January 30, 2006

Project Texas Roadhouse Madison, WI  
Project # 20050922.2  
Re Resubmittal: Urban Design Review

Please note the following revisions to the documents listed above:

**FRONT (NORTH) ELEVATION**

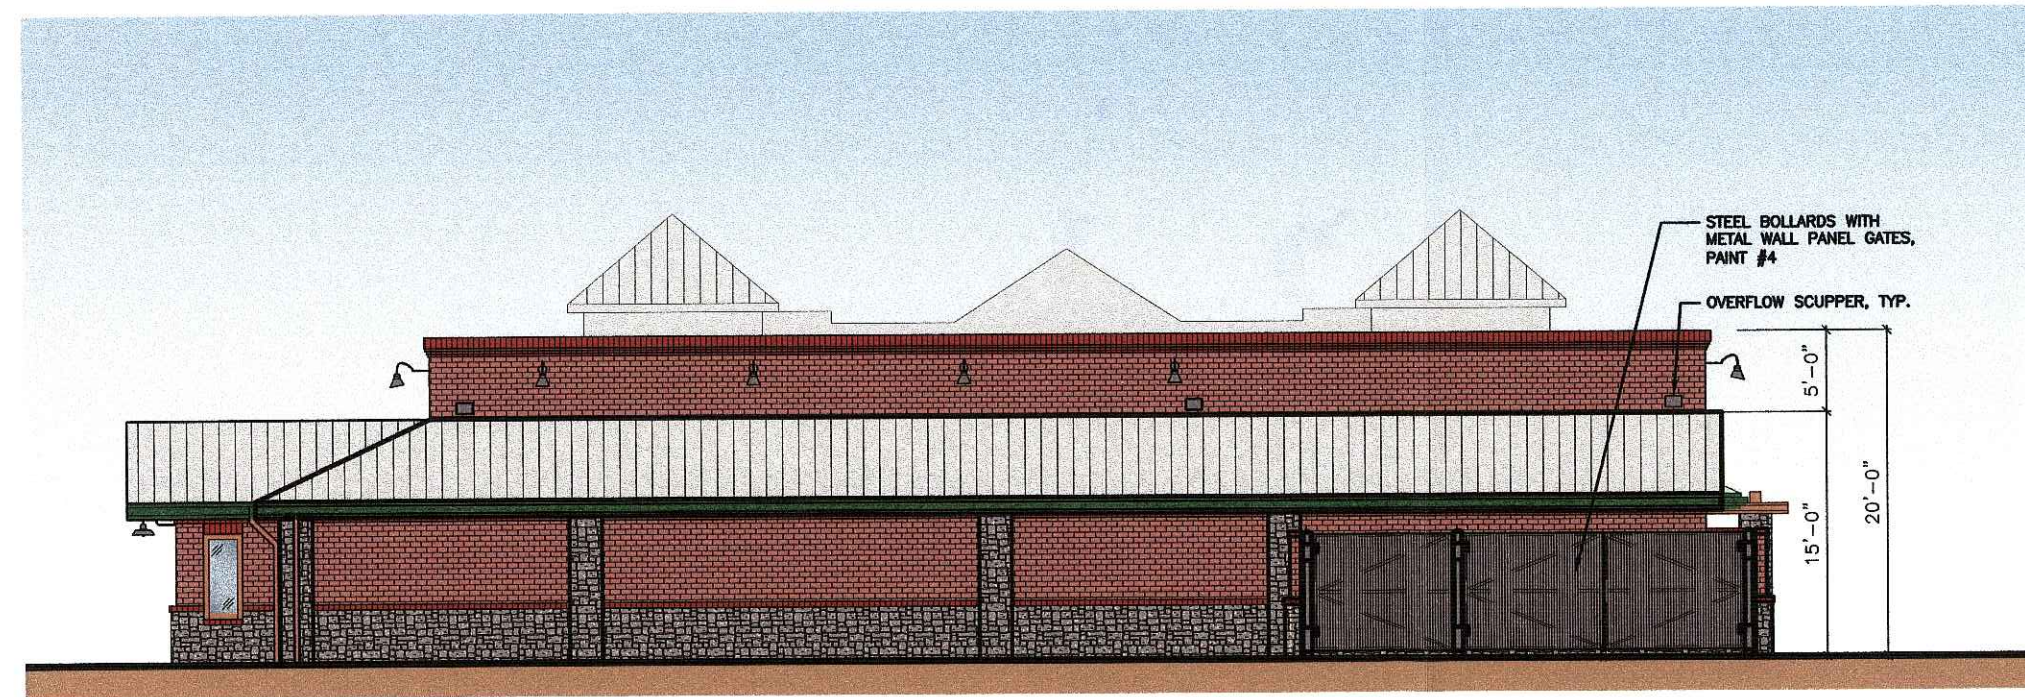
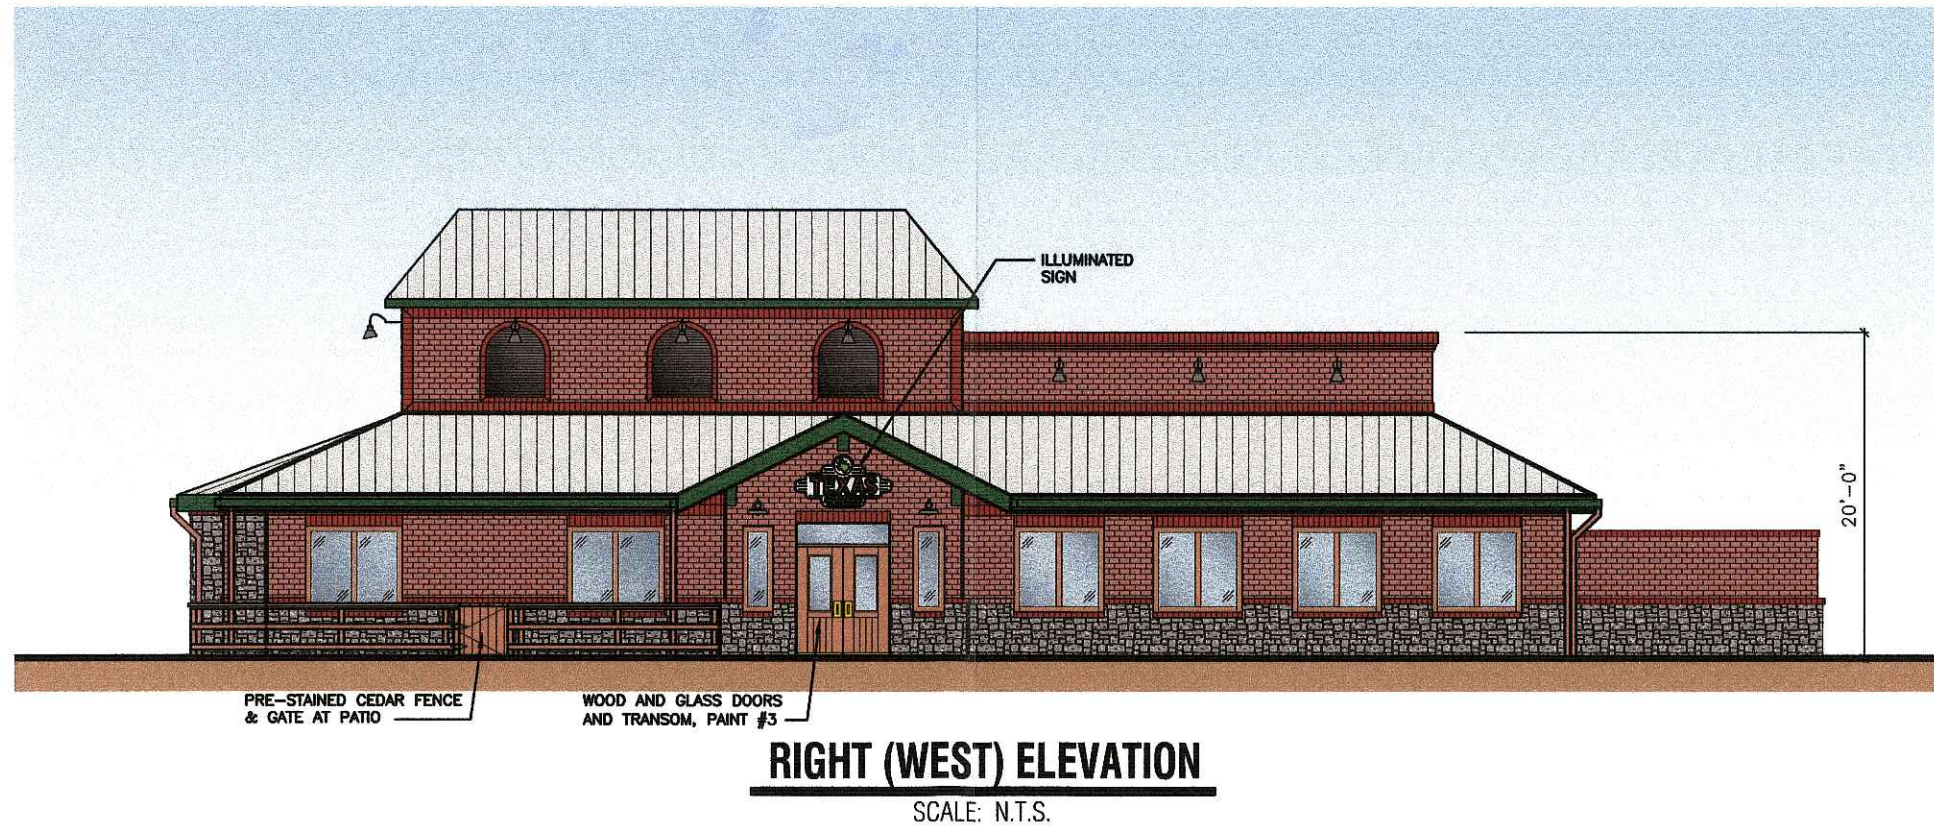
7. The architectural elevations have been revised to:
    - Remove the U.S. and State of Texas flags.
    - Incorporate full height brick with stone wainscoting.

**STOREFRONT ELEVATION**

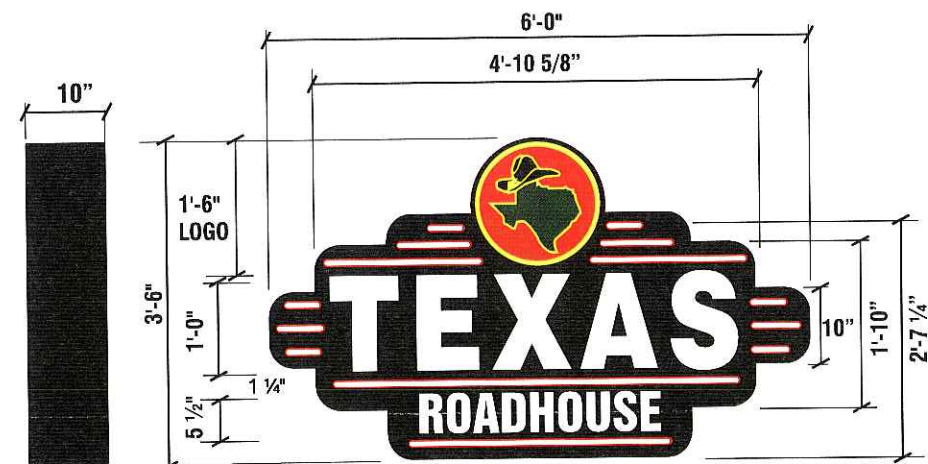
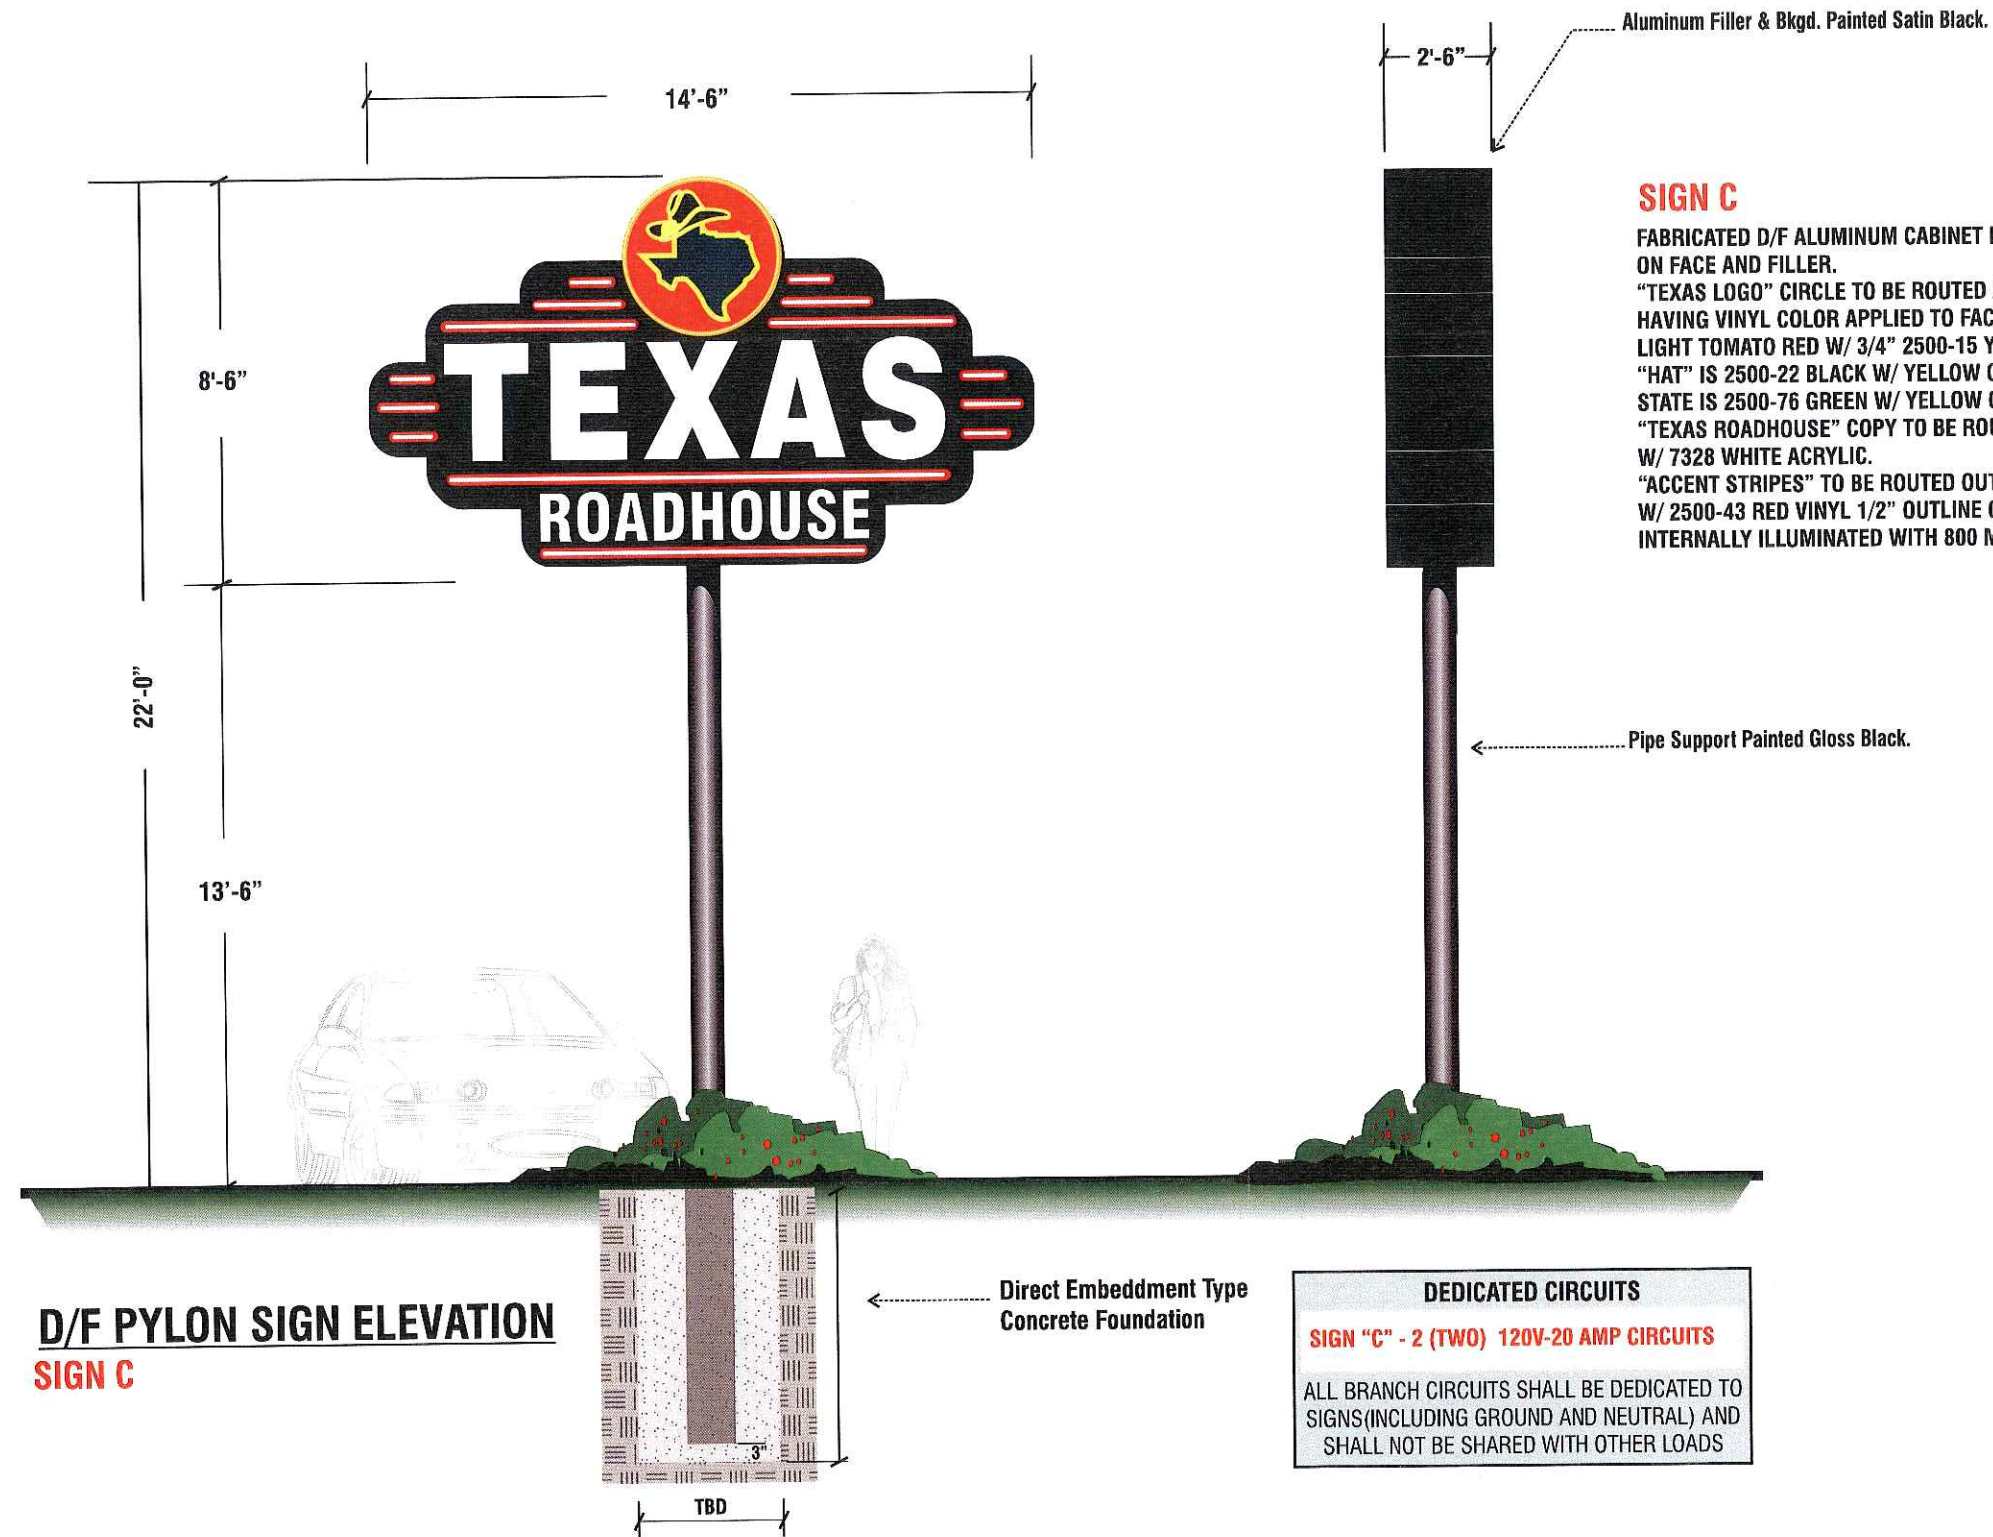
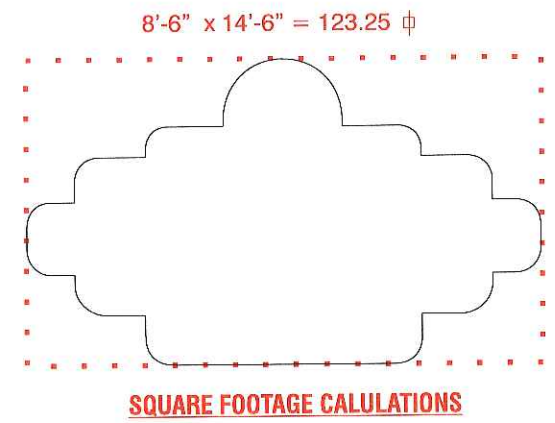
- All fixtures are positioned to accent the building façade and minimize spillage.
4. The signage exhibit has been revised to show that the exposed neon of the large wall sign is recessed within the "can." Also, the pylon sign and small wall sign above the entrance door were revised to be internally lit cabinets.
